# SAN FRANCISCO PLANNING DEPARTMENT

**MEMO**

**RE:** **Review and Comment on work proposed to abate Planning Enforcement Case No. 2017-015635ENF, addressing work completed without a Certificate of Appropriateness and proposed expansion of a penthouse and addition of a roof deck and gate, Case No. 2018-009197COA.**

**Re: 1470 McAllister Street**  
**Planning Case No.: 2018-009197COA**  
**Hearing Date: March 6, 2019**  
**Our File No.: 10403.02**

SCALE: 3/16" = 1'-0"

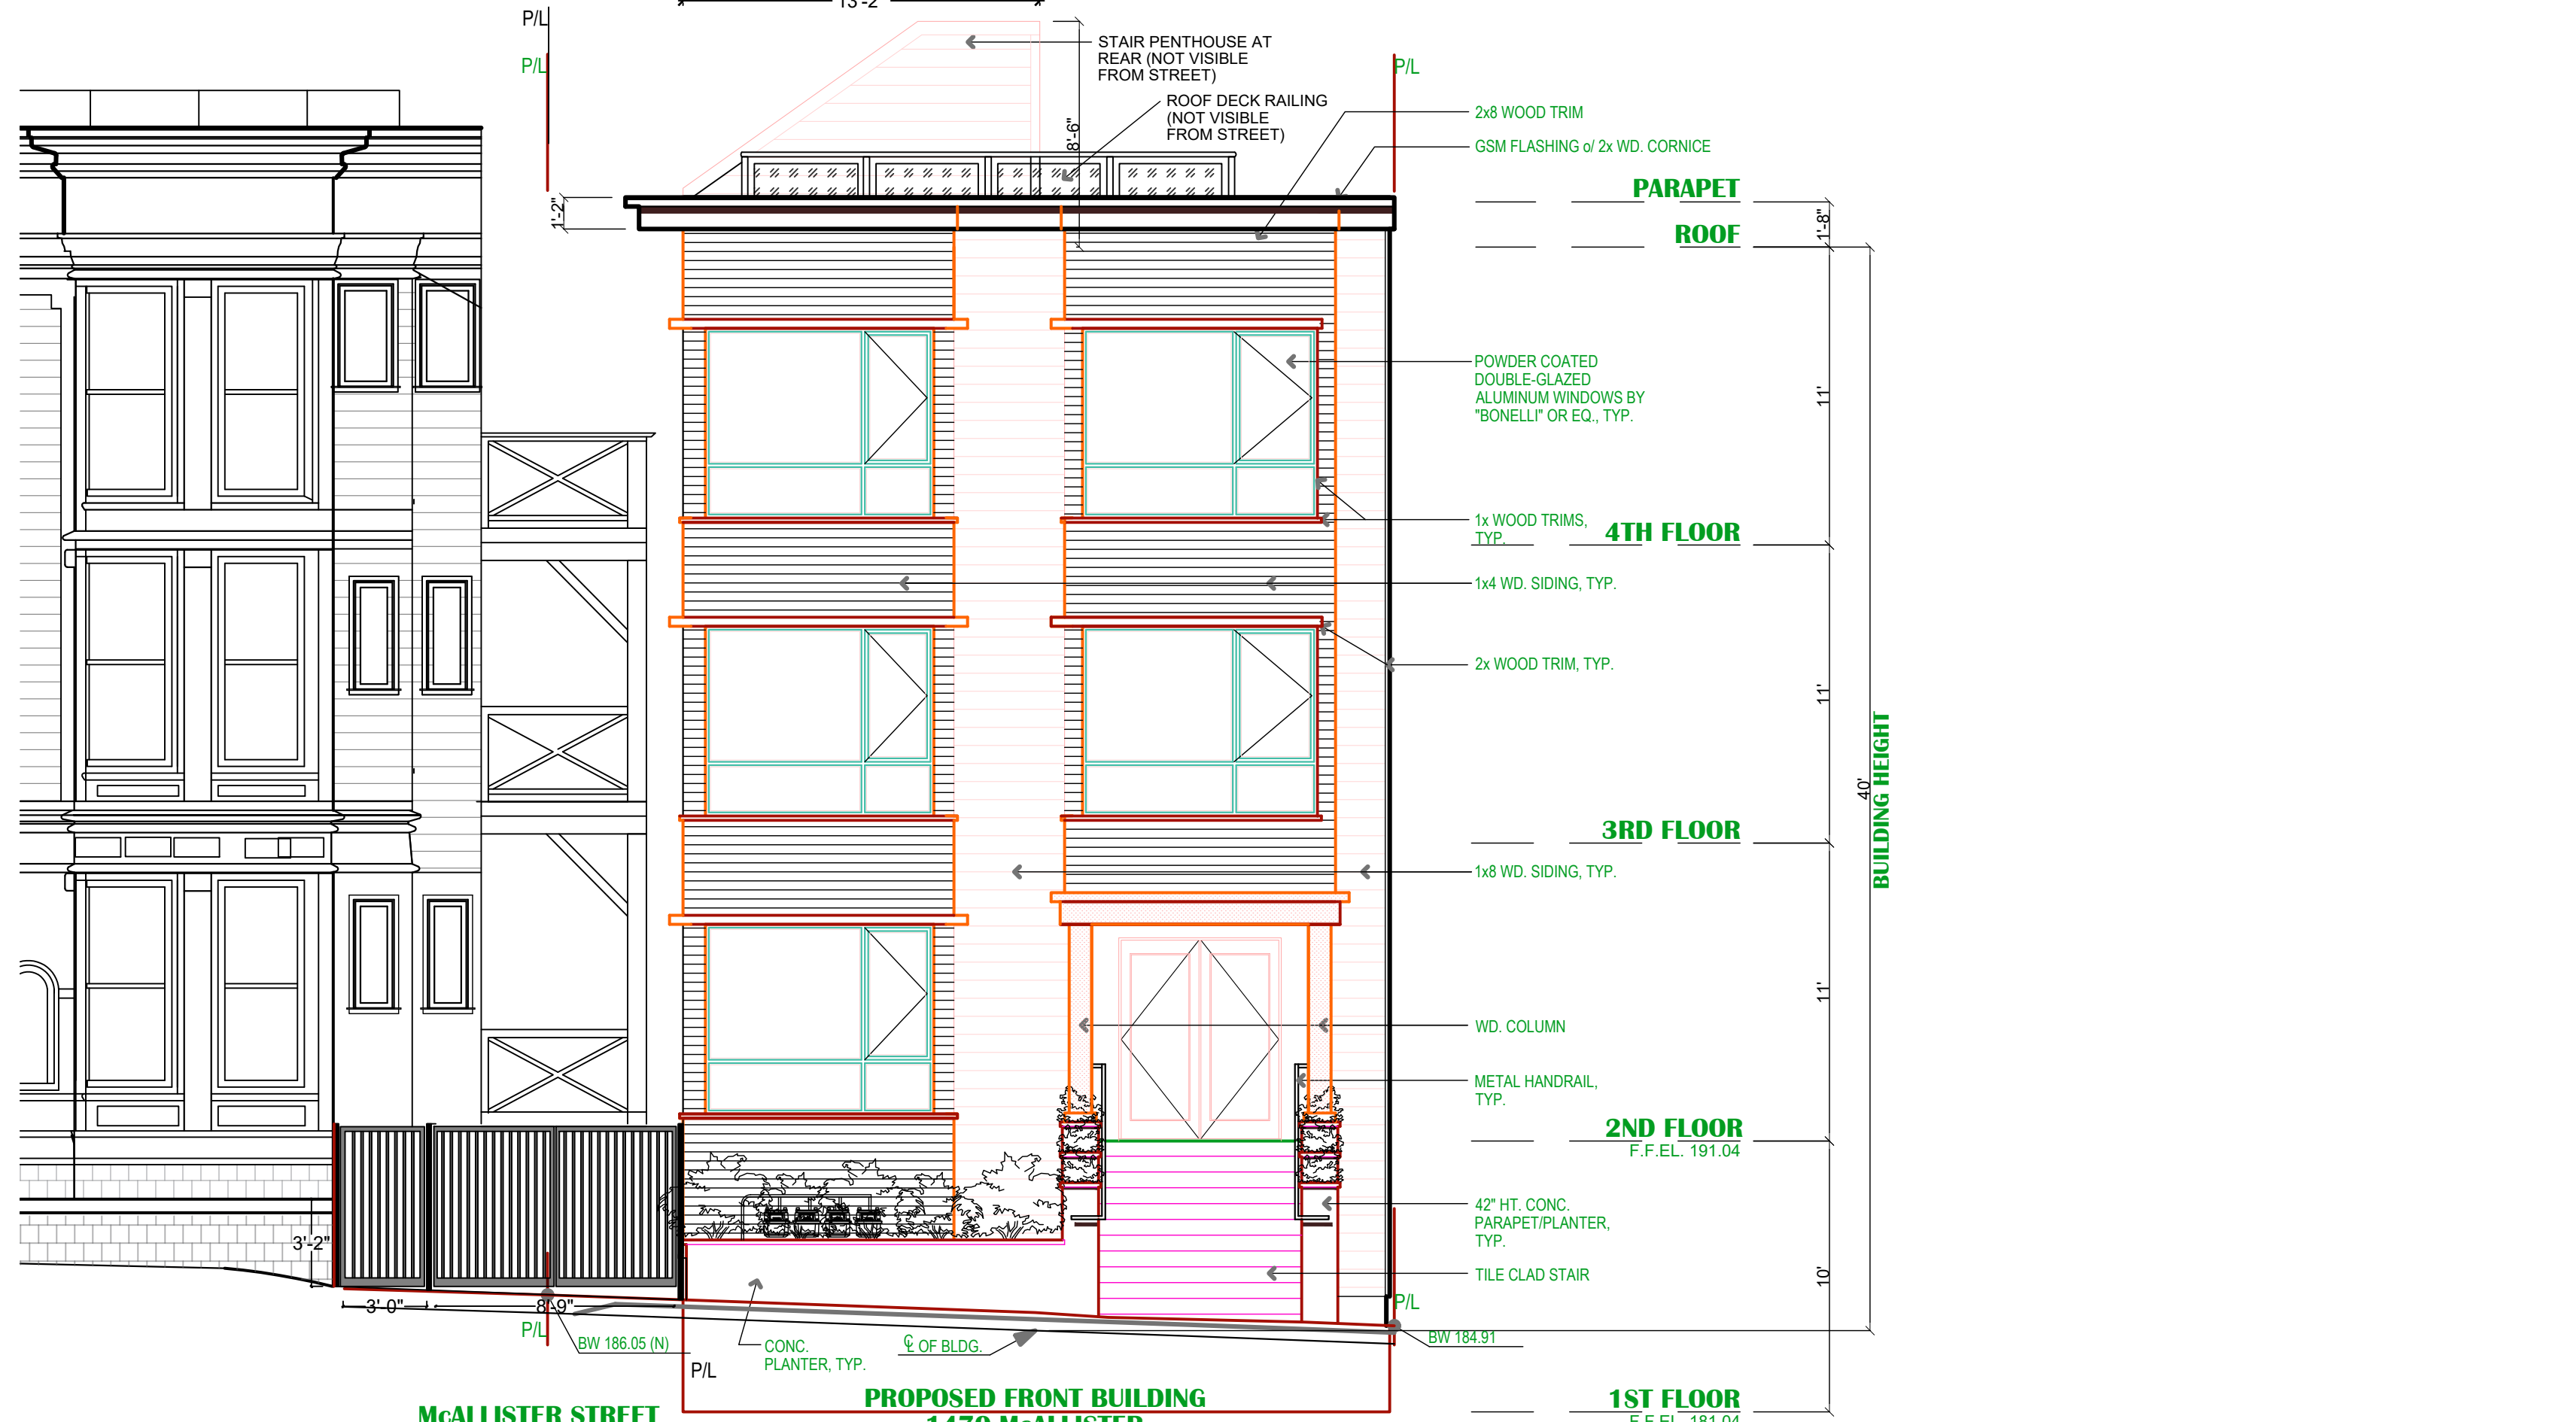
**Roof Cornice:** The building currently does not have a cornice, which is incompatible with the intense ornamentation found in the district. The proposed wood cornice is contemporary in form and detailing, and is reflective of the multi-stepped form of cornices in the district. It is also similar in its proportions and projection to cornices in the district. The proposed cornice will cap the building in a manner more similar to the rooflines found in the surrounding historic buildings. The Department recommends that a section detail of the cornice element be submitted for final design review.

**Window Trim:** The building currently employs no ornamentation, which is incompatible with the highly ornamented wood facades of the district. The proposed addition of raised wood horizontal trim above windows would make the façade multi-planar and provide some play of shade and shadow similar to that achieved at historic facades.

**Recommendation:** The Department recommends the finish, materials and dimensions of the gate be called out on plans to better analyze its compatibility with the district.
